DATA COLLECTION SURVEY
ON URBAN TRANSPORT
IN AFGHANISTAN

PART 2-3 DESIGN REVIEW OF SARA-E-SHAMALI INTERSECTION

Data Collection Survey for Urban Transport in Afghanistan
Design Review for Sara-E-Shamali Intersection

This report is to review the design of the Sara-e Shamali intersection done by Khatib & Alami, and to propose ideal design and project cost.

Figure- 3-1 Clearance of P3

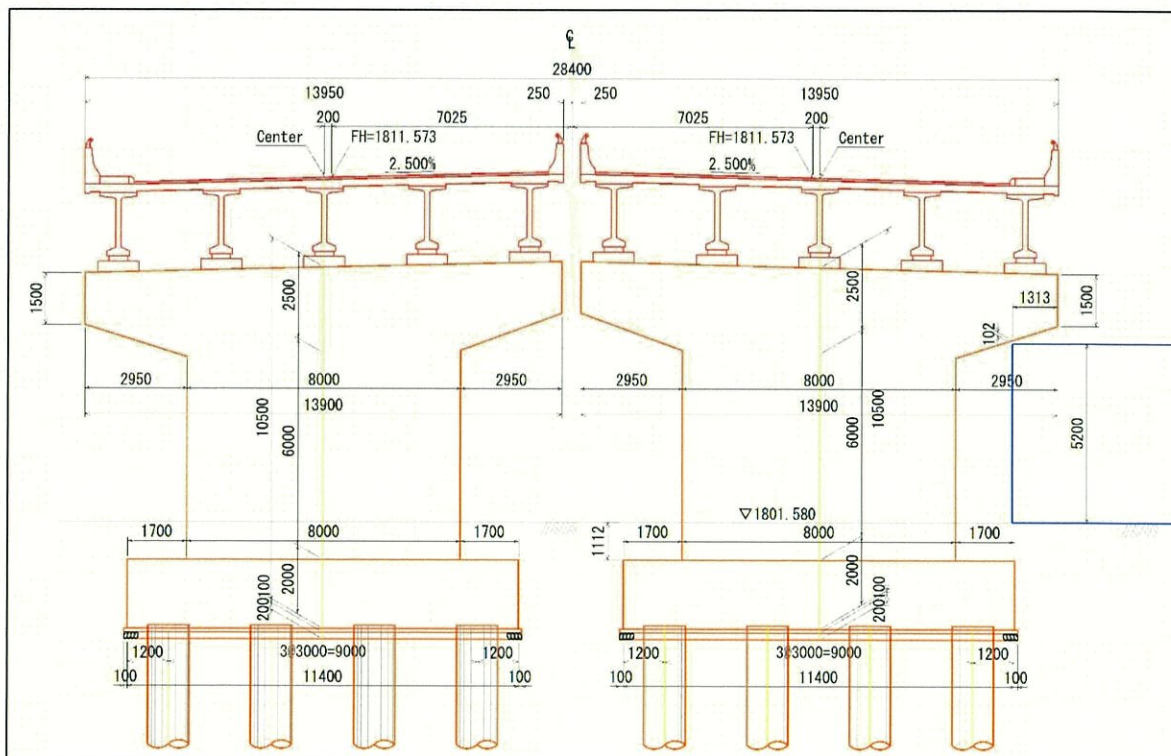
The planned height in the intersection is assumed to be the current height because it is difficult to change the height of the connecting road. The proposed elevation of the main road is set by the vertical profile that can secure the heights shown in Table 3-11. In this review, since the clearance of P3 is the control, it is confirmed that the clearance is secured against the existing height as shown in Figure 3-1. During the DD, the vertical alignment of the service road should be set along the existing height in the intersection to secure the necessary clearance.

Table- 4-1 Signal Timing of Original Intersection

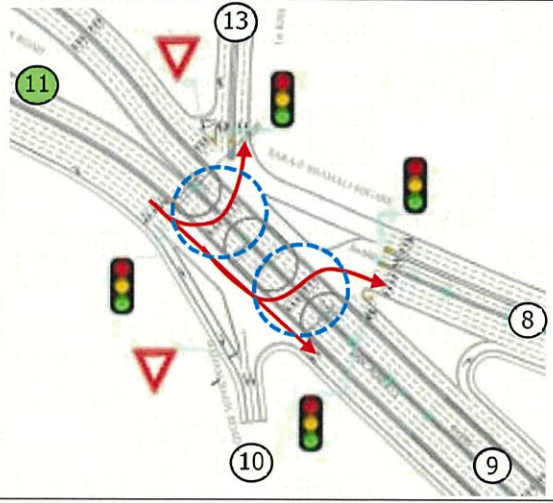
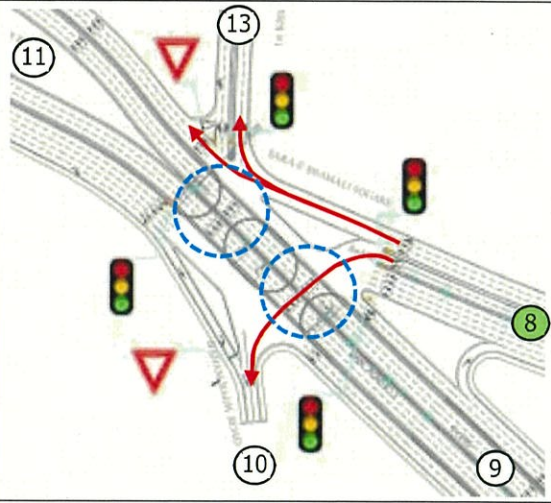
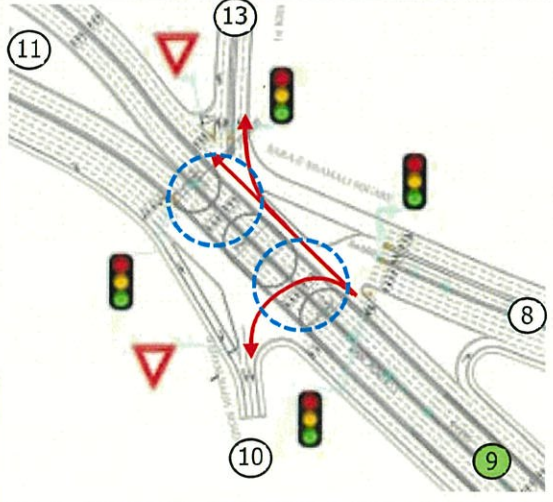
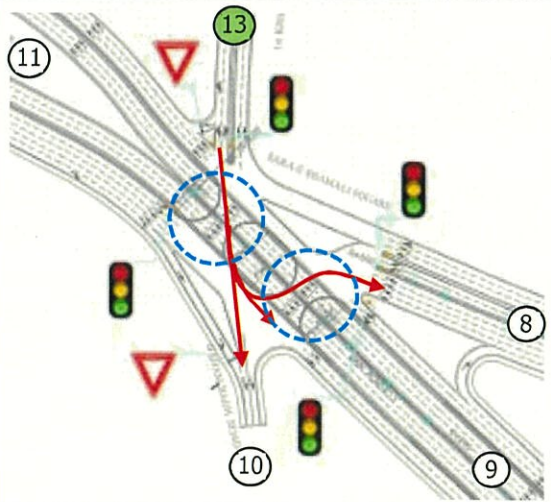
The problems in the original design are shown below. (yellow 3 sec, red (clearance time) 3 sec)

- ✓ Since there is no directional guidance in the intersection, drivers are not sure where to go.
- ✓ As a signalized roundabout, green time is provided for each leg, which reduces the traffic capacity of the intersection.
- ✓ Since the traffic flows in the intersection are complicated and the distance is long, the clearance time should be insufficient at 3 seconds.
- ✓ At the blue circles shown on the Table 4-1, there is a concern that a serious accident may occur due to the complicated traffic flows.
- ✓ As two multi-pillar piers are located in the intersection, the sight distance in the intersection should be insufficient.

Figure- 4-1 Improved Plan after Review

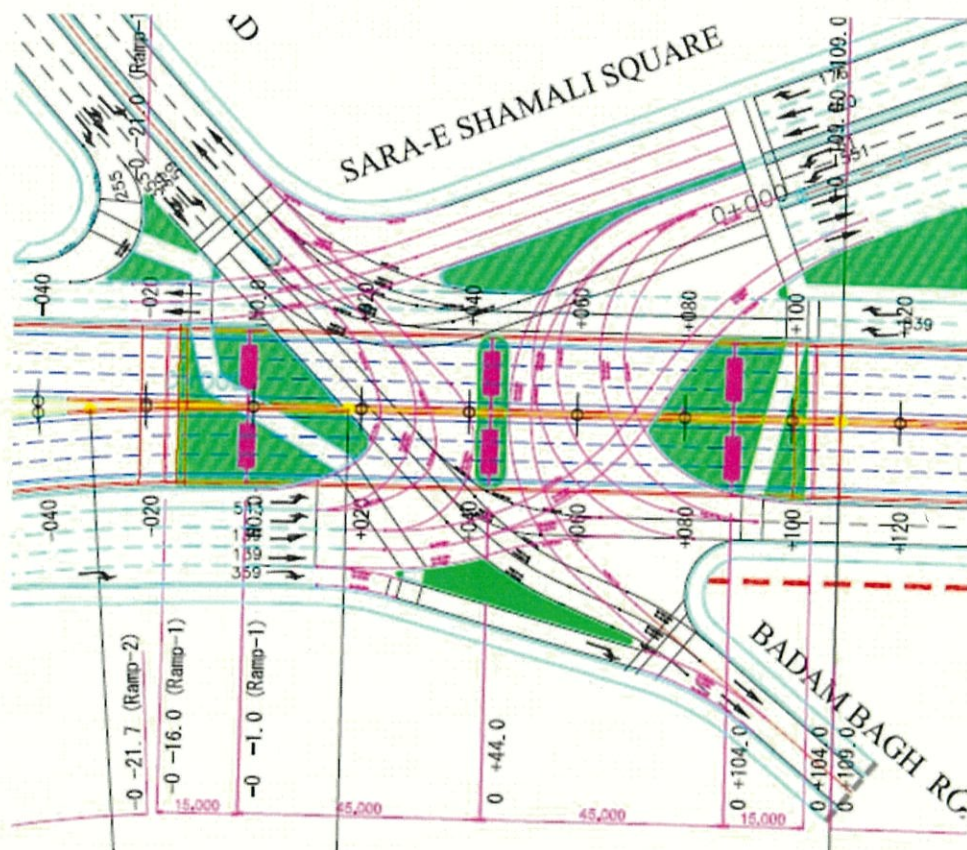
The intersection that has designed as a signalized roundabout was redesigned as a signalized intersection in this review.

- ✓ A traffic island was placed in the center of the intersection to secure the location of the bridge piers.
- ✓ The traffic channels were designed to consider the signalization of the east-west traffic (Sarak-E Kabul Charikar Road and Airport Road) marked in magenta and the north-south traffic (Baraki Sara-E Shamali Road and Airport Road) marked in black.
- ✓ To ensure flow to the right-turn lane, a taper was installed to avoid the queue length.
- ✓ The bridge abutments were moved back to provide walkways.

PLAN OF INTERSECTION WITH SATELLITE IMAGE SCALE = 1:2000

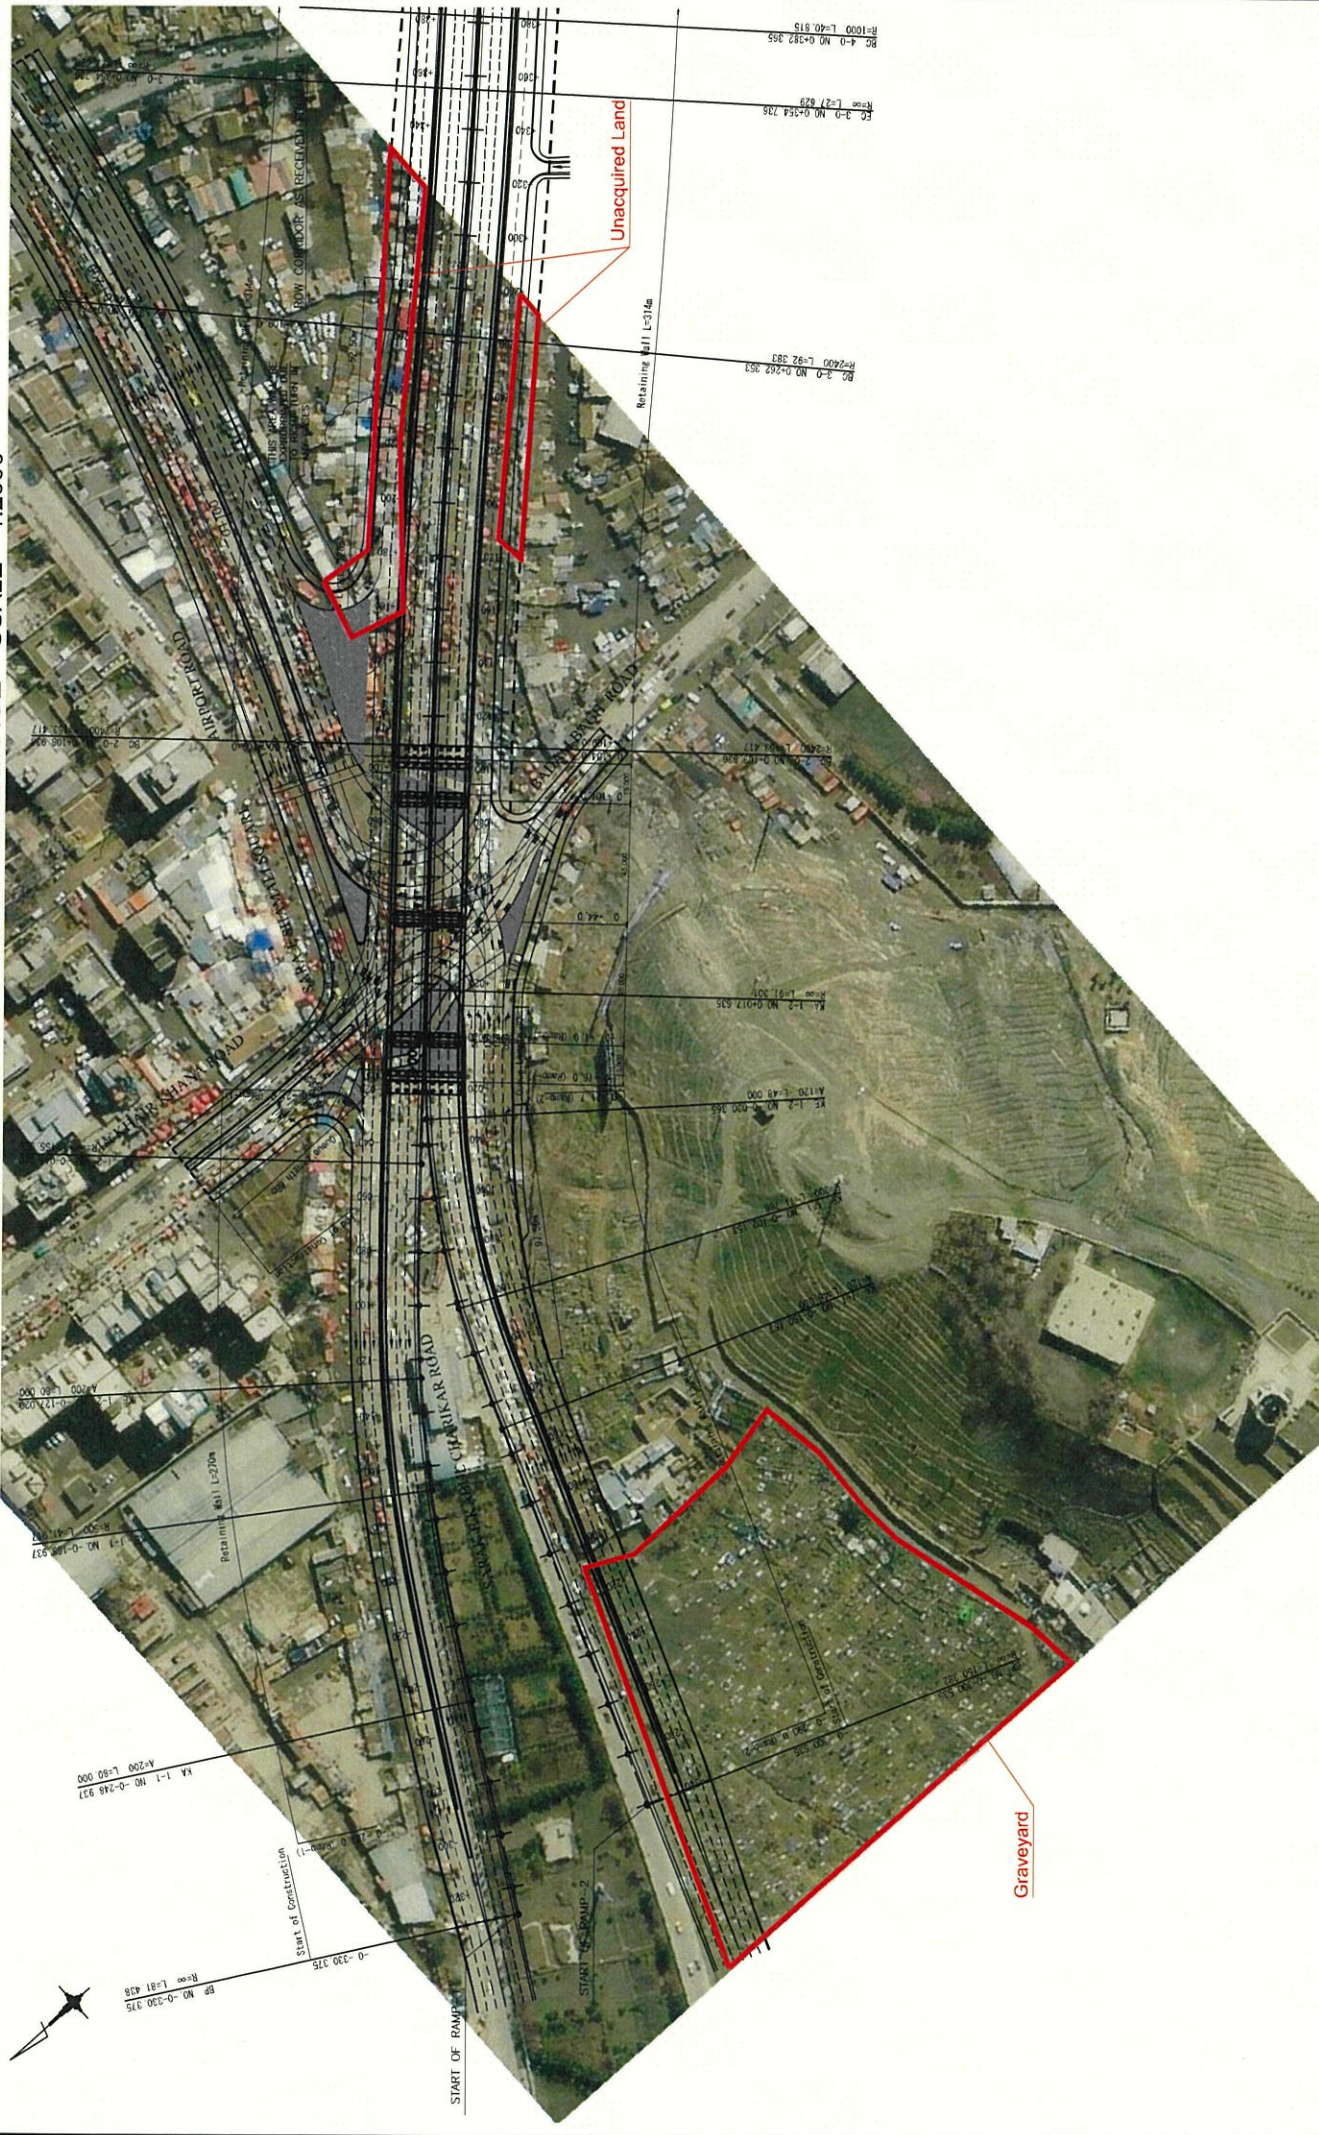
Referring to the attached drawing "PLAN OF INTERSECTION WITH SATELLITE IMAGE", the following items should be verified during the detailed design.

- ✓ The layout of the Ramp-2 and the cemetery shown in the Chapter 5 (7) should be clarified and the extent of land available for construction should be confirmed.
- ✓ The road formation width on the plan in the original design is 54.8m and the ROW shown on the plan is 60m. However, the road width in the master plan of Kabul City is only 50m. The width of actual ROW should be confirmed in site and reflected in the detailed design.
- ✓ At the time of the review, it has been confirmed that the land acquisition for the approach section of Baraki Sara-E Shamali Road is still in progress. At the time of detailed design, the progress of land acquisition shall be confirmed with KM.
